**Product Bulletin #:** 121002  
**Model:** 21B FAB  
**Topic:** Hanger Wear Pad  
**Effective Date:** December 10, 2002  
**ECR #:** 13826

A wear pad has been released for the use in both the front and rear hangers of the fabricated 21B suspension (21B-Fab).

**NEW WEAR PAD PART #: 703736-01**

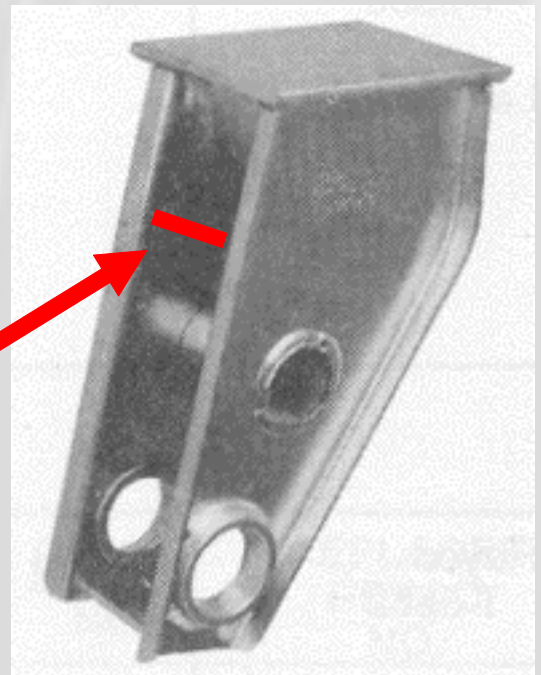
It has been designed as a direct fit "OVER" the existing wear pad (Part # 08592-01).

**To install:**  
**Weld across the front and rear face.**
